Work Order ID 71570

Item Name: Bracket

From: David Shepherd <dshepherd@dartaero.com>
Sent: August 4, 2011 9:00 PM
To: 'Marc Bellavance'
Subject: FW: W/O NCR on D2804-1 Bracket
Attachments: image001.png; Oversized Holes on D2804 vs SR-P447-1A.pdf; D2804-RevC.pdf

8.5 D2803/D2804/D2990 Bracket Lug Analysis

DESIGN CP	DRAWN BY CP	DART AEROSPACE LTD HAWKESBURY, ONTARIO, CANADA	
CHECKED <i>[Signature]</i>	APPROVED <i>[Signature]</i>	DRAWING NO. D2804	REV. C SHEET 2 OF 2
DATE 06.10.16		TITLE STA 155 BRACKET	SCALE 1:3

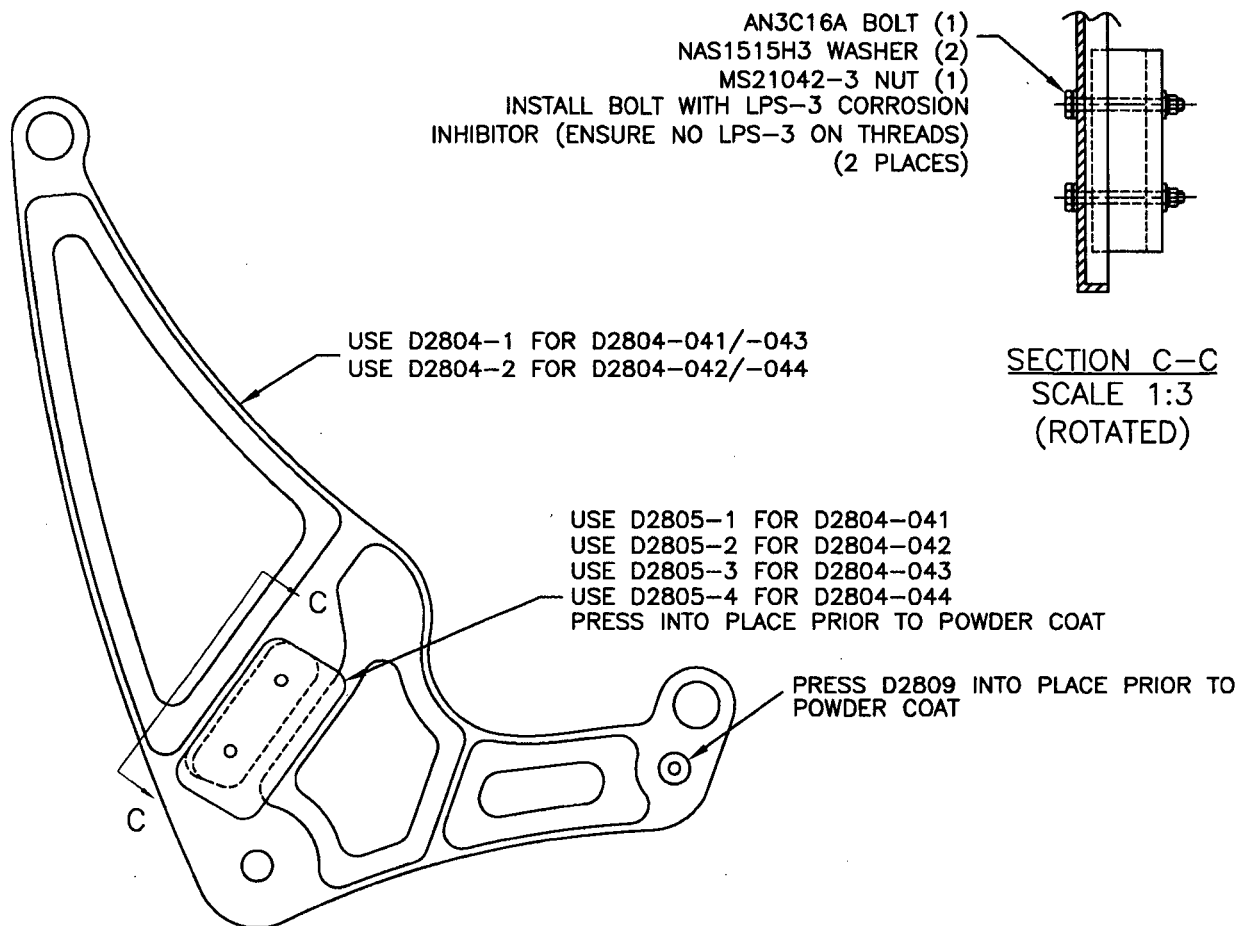
NCR: 71576		WORK ORDER NON-CONFORMANCE (NCR)						
DATE	STEP	Description of NC Section A	Corrective Action Section B			Verification Section C	Approval Chief Eng	Approval QC Inspector
			Initial Chief Eng	Action Description Chief Eng	Sign & Date			
11/08/03	110	1 part, the .757 hole are too big of .002" over tol. R.C. operator error	11/08/05 GSIC12	PER ATTACHED ANALYSIS, THE DEVIATION IS ACCEPTABLE: THE (MARGINS) ARE STILL POSITIVE AND SAFE. THIS W/OUT!	11/08/05	D.A. 11/08/05	11/08/05	11/08/05

Qty(1) out of qty(6) D2804-1 Bracket have $\varnothing 0.757 +0.005/-0.000$ holes outside tolerance. Actual measurement is $\varnothing 0.765$, this is true for both holes.

As per attached, I've run the calculations and the deviation seems acceptable but still need to run this by you for approval.

I agree ... Based on your attached analysis, this deviation is acceptable.

$D := 0.757 \cdot \text{in}$	0.705 in	Diameter of hardpoint hole
$R := 0.625 \cdot \text{in}$		Radius of hardpoint lug
$t := 0.5 \cdot \text{in}$		Thickness of bracket at hardpoint
$F_{\text{max}} := F_{\text{b84}}$	$F_{\text{max}} = 1937.5 \cdot \text{lb}$	Maximum hardpoint load (from section 7.1)
$FF = 1.15$		Fitting factor

$A_t := (2 \cdot R - D) \cdot t$	$A_t = 0.247 \cdot \text{in}^2$	0.2425 in^2	Tensile area
$P_{\text{ut}} := \frac{F_{\text{max}} \cdot FF}{A_t}$	$P_{\text{ut}} = 9039.047 \cdot \text{psi}$	9188.1433 psi	Ultimate tensile stress
$MS28a := \frac{F_{\text{cy}}}{P_{\text{ut}}} - 1$	$MS28a = 2.761$	2.7004	Margin of Safety

$A_b := D \cdot t$	$A_b = 0.379 \cdot \text{in}^2$	0.3825 in^2	Bearing area
$P_{\text{ub}} := \frac{F_{\text{max}} \cdot FF}{A_b}$	$P_{\text{ub}} = 5886.724 \cdot \text{psi}$	5825.1634 psi	Ultimate bearing stress
$f := \frac{R}{D} - 0.5$	$f = 0.326$	0.314	Reduction factor for $e/D < 1.5$
$MS28b := \frac{F_{\text{bry}} \cdot f}{P_{\text{ub}}} - 1$	$MS28b = 1.71$	1.667	Margin of Safety

$e := R - 0.5 \cdot D$	$e = 0.247 \cdot \text{in}$	0.2425 in	Edge distance
$A_s := 2 \cdot e \cdot t$	$A_s = 0.247 \cdot \text{in}^2$	0.2425 in^2	Shear area
$P_{\text{us}} := \frac{F_{\text{max}} \cdot FF}{A_s}$	$P_{\text{us}} = 9039.047 \cdot \text{psi}$	9188.1433 psi	Ultimate shear stress
$MS28c := \frac{F_{\text{sy}}}{P_{\text{us}}} - 1$	$MS28c = 1.649$	1.6063	Margin of Safety
